**ADDENDUM NO. [1]**

**Date: September 13, 2019**

**RE: SCHOOL DISTRICT OF LA CROSSE  
7 RIVERS CHARTER SCHOOL  
225 5<sup>TH</sup> AVE SOUTH  
LA CROSSE, WI 54601  
HSR 19003**

4 SOUTH ELEVATION  
1/8" = 1'-0"

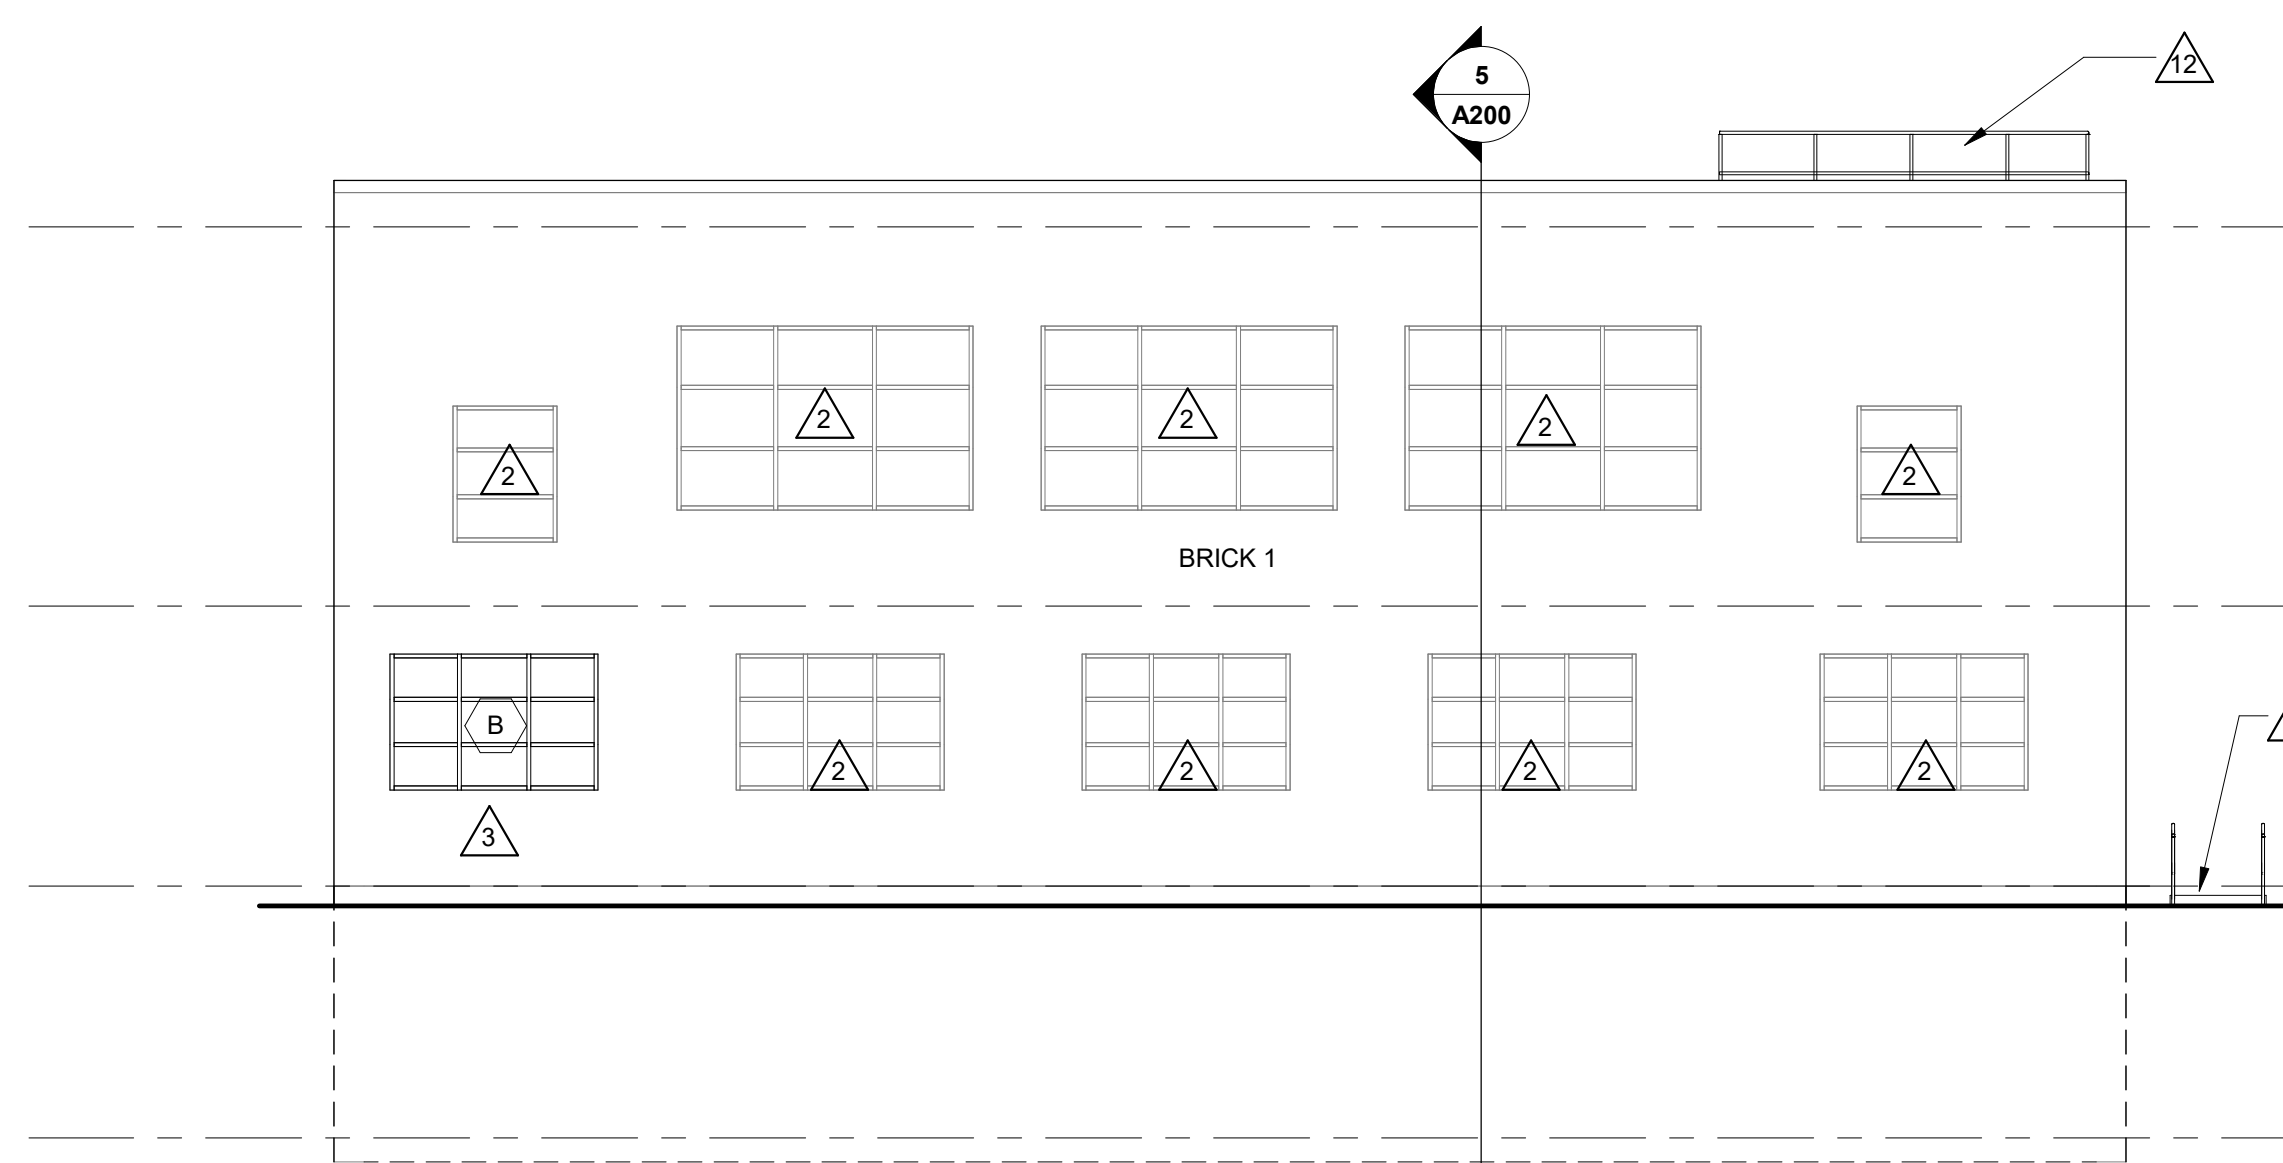
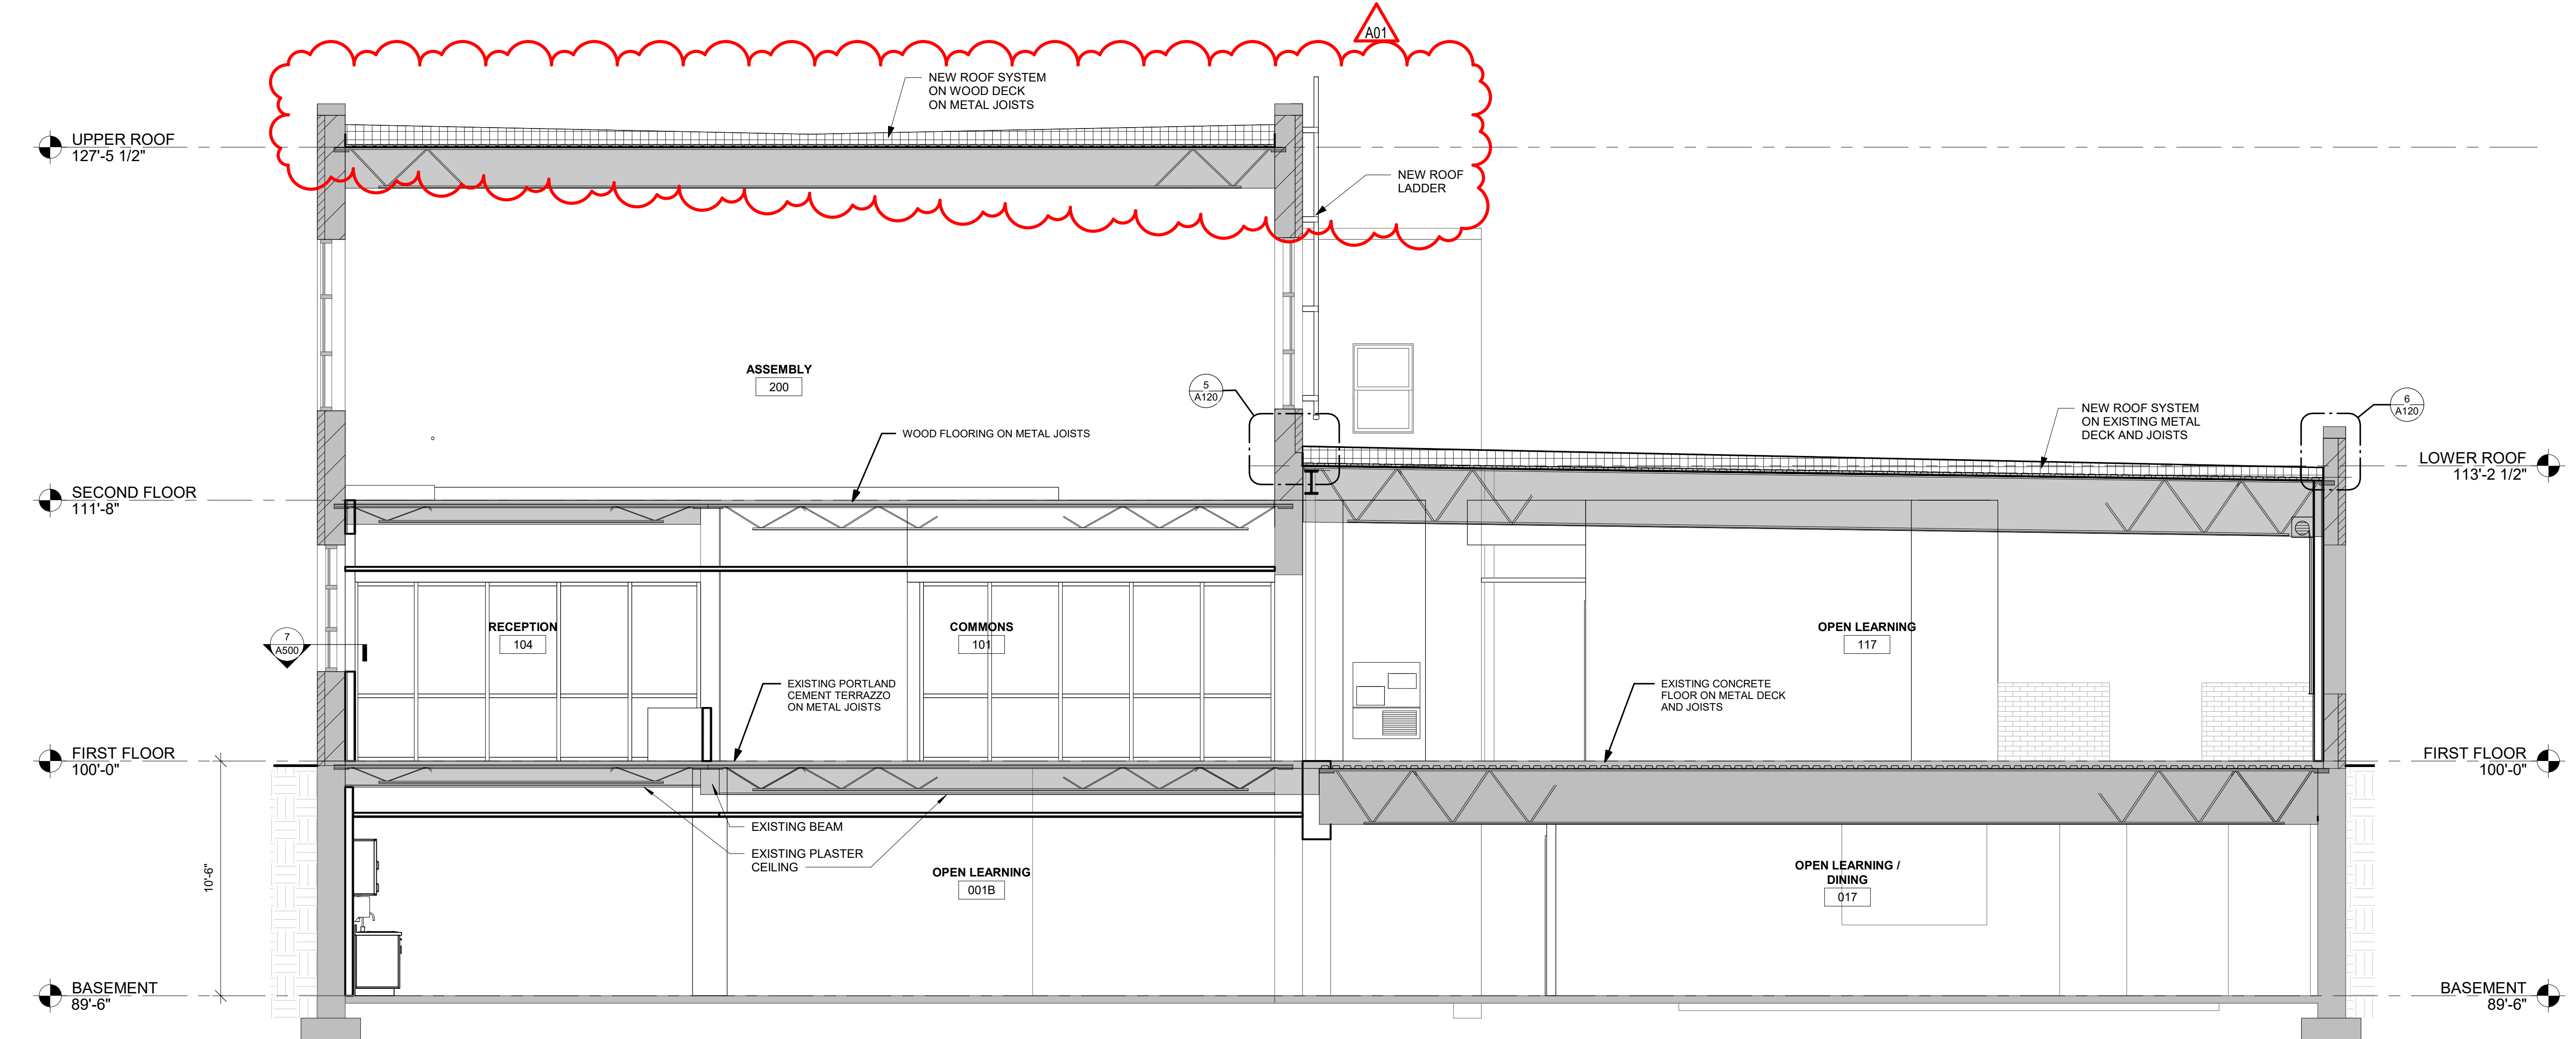
25. Sheet A200 EXTERIOR ELEVATIONS AND BUILDING SECTIONS 30 x 42 attached hereto

- a. Revisions clouded on Drawing.
- b. Roof ladder added to access south roof.
- c. Over flow drain lambs tongues located.

**1** WINDOW ELEVATIONS

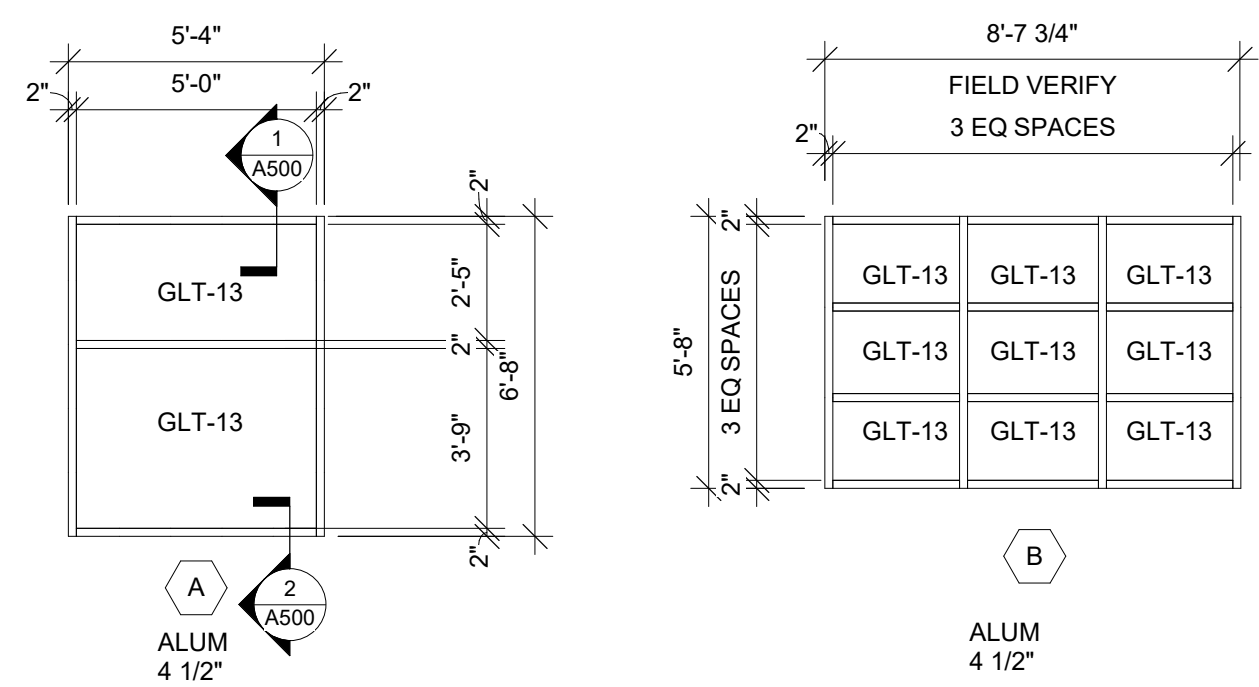
26. Sheet A201 INTERIOR ELEVATIONS 30 x 42 attached hereto

- a. Revisions clouded on Drawing.
- b. Window elevation BL4 changed to BL3.
